NUMBER: 18-102-22

DATE: May 24, 2022

This bulletin supersedes Technical Service Bulletin (TSB) 18-012-21 REV. B, date of issue June 26, 2021, which should be removed from your files. All revisions are highlighted with **asterisks**** and include and includes updated notes and inspection section.**

Flash: Powertrain Control Module (PCM) Updates

Fig. 1
CP3.3 Design Pump

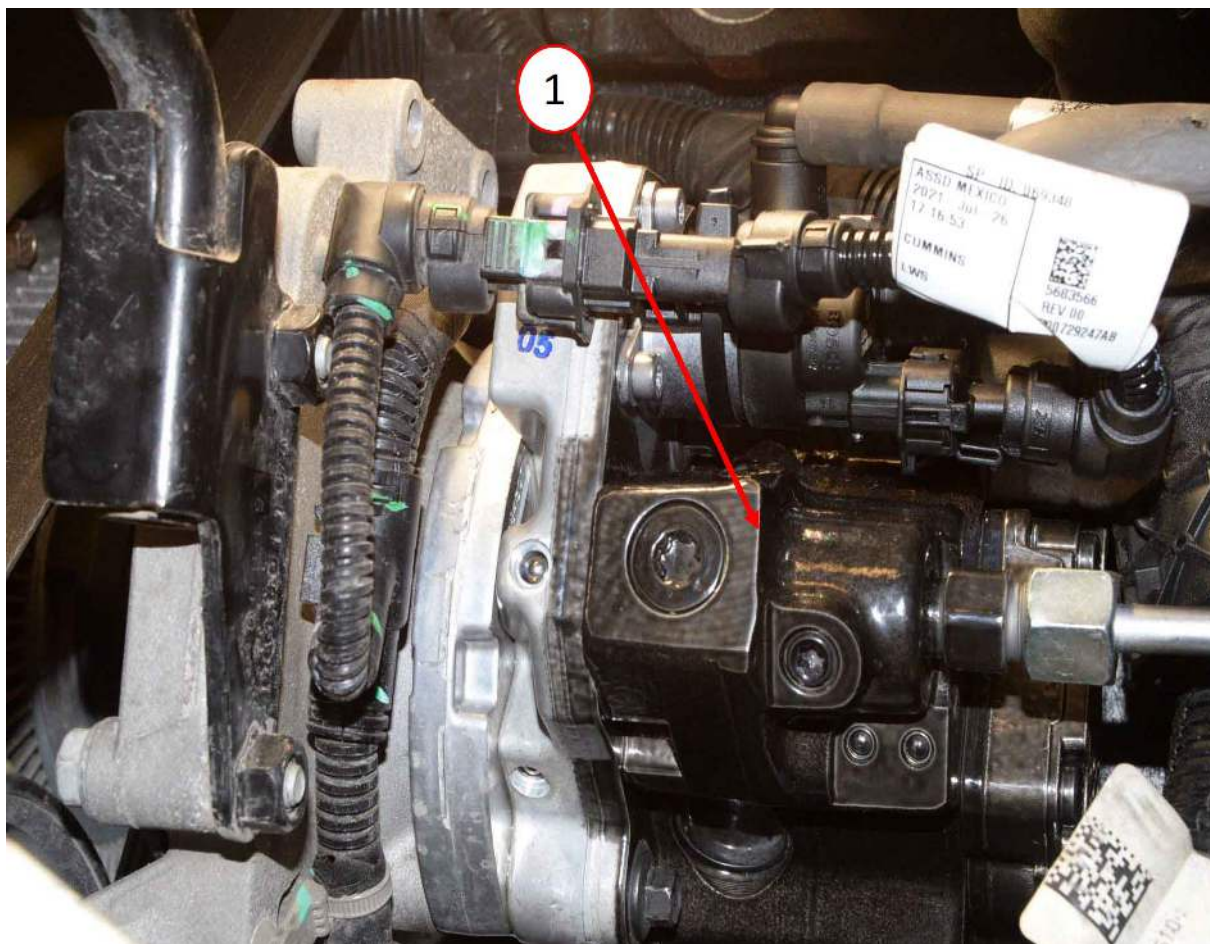
NOTE: **The only calibration available will be for the updated CP3.3 design High-Pressure Fuel Injection Pump (Fig. 1) . Please ensure that recall Y78 has been completed first before proceeding with this update.

1. Inspect the High-Pressure Fuel Injection Pump to see which pump is currently installed on the vehicle (Fig. 1) . Also review the vehicle VIP report to see if campaign Y78 has been performed.

2. Does the VIP report indicate that Y78 has been performed, and is the vehicle equipped with the new design fuel injection pump released under the campaign?
 - YES>>> Proceed to [Step 1](#).
 - NO>>> Perform the Y78 campaign first. Once the campaign is performed, new pump installed and PCM updated, the PCM will have all of the updates listed in this document. This Bulletin does not apply.**
